Adrienne Sandoval, Division Director  
Oil Conservation Division

**30-045-24842 PAN AMERICAN FEDERAL GAS COM B #001E**  
**HILCORP ENERGY COMPANY**

Re: Permanent Abandonment  
Well: Pan Am Federal B #1E

### Pan Am Federal B #1E

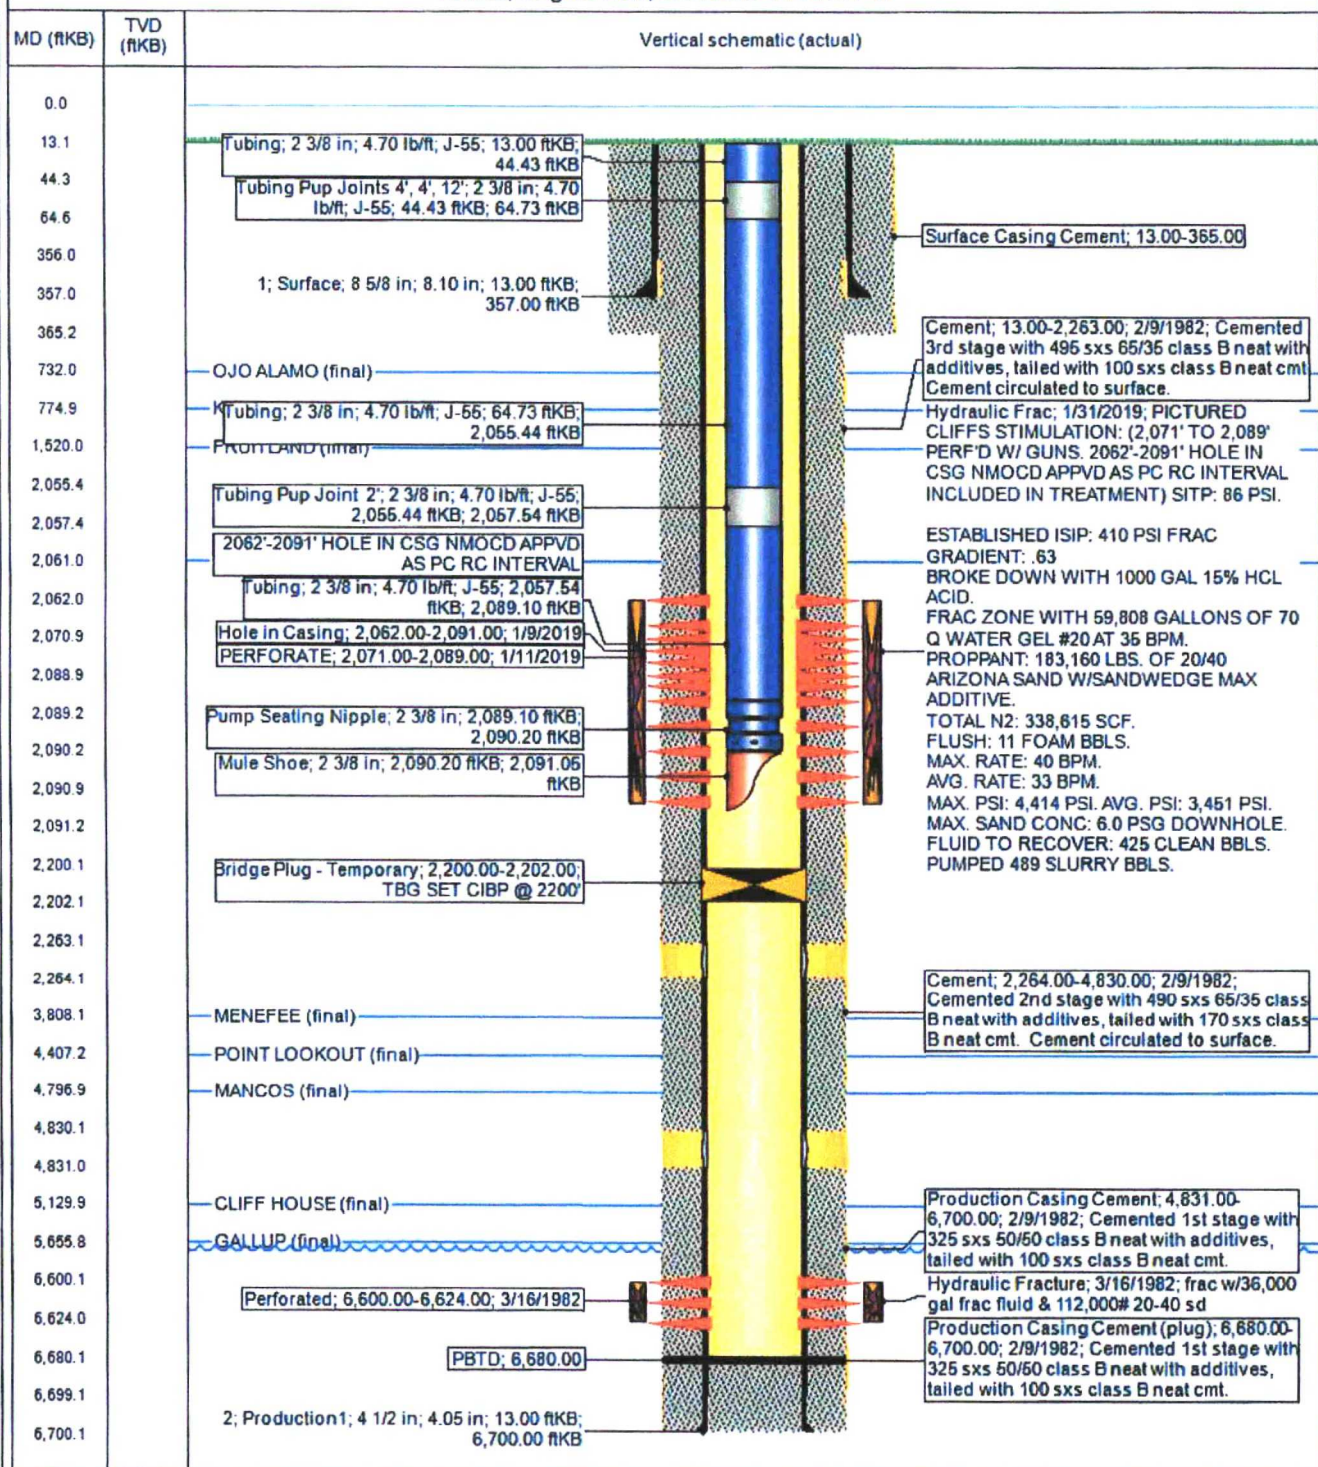
- Notify NMOCD 24hrs prior to beginning operations.
- In addition to BLM COAs, ensure the following tops are covered:
- 5,705'-5,605'. OCD Gallup pick @ 5,655'
  - 3,780'-3,680'. OCD Mesaverde pick @ 3,730'
  - 2,800'-2,700'. OCD Chacra pick @ 2,750'
  - 1,870'-1,770'. OCD Fruitland pick @ 1,820'.
  - 810'-585'. OCD Kirtland pick @ 760'. Ojo Alamo pick @ 635'.

1. Plugging operations authorized are subject to the attached "General Requirements for Permanent Abandonment of Wells on Federal and Indian Lease."
2. Farmington Office is to be notified at least 24 hours before the plugging operations commence (505) 564-7750.
3. Run and submit electronic copy of a CBL for verification to the following addresses: [jkillins@blm.gov](mailto:jkillins@blm.gov) , [jhoffman@blm.gov](mailto:jhoffman@blm.gov) and [Brandon.Powell@state.nm.us](mailto:Brandon.Powell@state.nm.us) . Based on CBL results inside/outside plugs and volumes will be adjusted accordingly. Please review the General Requirements document to ensure volumes meet required excess inside and outside casing.
4. BLM pick top of Chacra: 3190 ft. Add plug or modify Plug #5 to cover 3140-3240 ft.
5. BLM pick top Mancos: 4794 ft. Add a plug or modify Plug #3 to cover 4744 – 4844 ft.

- BLM geologist's pick for the top of the Kirtland and Lewis formations varies from operator's.
- Log analysis of reference well #2 (attached worksheet) indicates the Nacimiento and Ojo Alamo sands investigated contain fresh water ( $\leq 5,000$  ppm TDS).
- Please ensure that the tops of the Dakota, Gallup, Mancos, Mesaverde (Cliff House), Pictured Cliffs, Fruitland, and Kirtland Formations, as well as the entire Ojo Alamo fresh water aquifer identified in this report are isolated by proper placement of cement plugs. This will protect the fresh water sands in this well bore.
